BALLARD MINE

SUPPLEMENTAL TECHNICAL MEMORANDUM
MONITORED NATURAL ATTENUATION REMEDY FOR
GROUNDWATER

FINAL – REVISION 2

COMMENTS AND COMMENT RESPONSE DOCUMENTS

Figure 3-3. Plot of Total Selenium Concentrations Over Time in Wells Formation Monitoring Locations

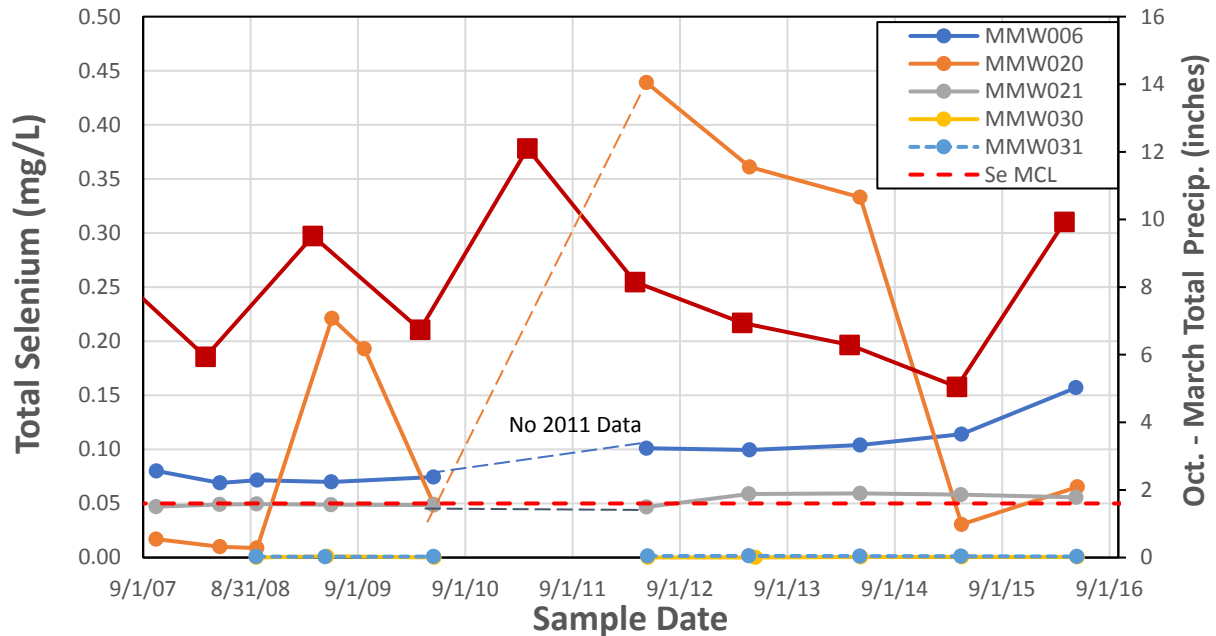
11. P. 3-12, "Contaminant Trends" subheading, last paragraph. The statement about the response at MMW006 and MMW021 to elevated Se concentrations at MMW020 does not appear to be well-supported by the data in Figure 3-3; in fact, it is difficult to discern any clear relationship between those data sets. A different possible interpretation of the data for MMW006 is that they seem to have an increasing trend. This is not mentioned in a discussion of plume stability like that presented for alluvial groundwater. If this trend were considered an indication of a potentially expanding plume (e.g., since a lack of an increasing concentration trend is taken to suggest a static plume and attenuation earlier in the TM for the alluvial groundwater), would that call into question the statement on p. 3-6 concluding that the data for MMW030 suggest that Se contamination in the Wells Formation groundwater is confined near the West Ballard Pit? Please present this interpretation as a hypothesis, and acknowledge and disclose uncertainty.

11. Sec. 3.2.2, paragraph after Figure 3-3. Saying that MMW006 and MMW021 show a lagged/muted response to concentrations in MMW020 seems like a stretch based solely on the data plotted in Figure 3-3. Recommend re-ordering the list of bullets, as it may be more credible to make that statement after you’ve presented the hypothetical explanation as found in the subsequent bullets.

P4 Response (SC-11): *Interpreting data for the Wells Formation is difficult, because, as stated in the memo, the monitoring wells are installed within different stratigraphic levels in the Wells Formation and in some cases are separated by faults. However, the statement regarding the response in selenium concentrations in MMW006 also is based on other data presented in the Ballard Mine RI Report. Based on geological and potentiometric data, only MMW006 and MMW021 appear to be in a similar hydrogeologic unit as detailed in Section 5.1.5.4 of the Ballard Mine RI Report (Figure 5-1 attached below). Each of the Ballard Site wells installed in the Wells Formation monitoring network responded to the large 2011 recharge event and provided some important information regard the hydrogeology of this deeper aquifer.*

- It is reasonable, and even probable, that both MMW006 and MMW021, respond to increases in concentrations observed at MMW020 in a more delayed manner as flow has been transported across lower permeability bedding within the formation. The new cross-section that will be added to the memo will be used to help illustrate this concept of cross bedding flow (new Drawing 3-2, see response SC-5).
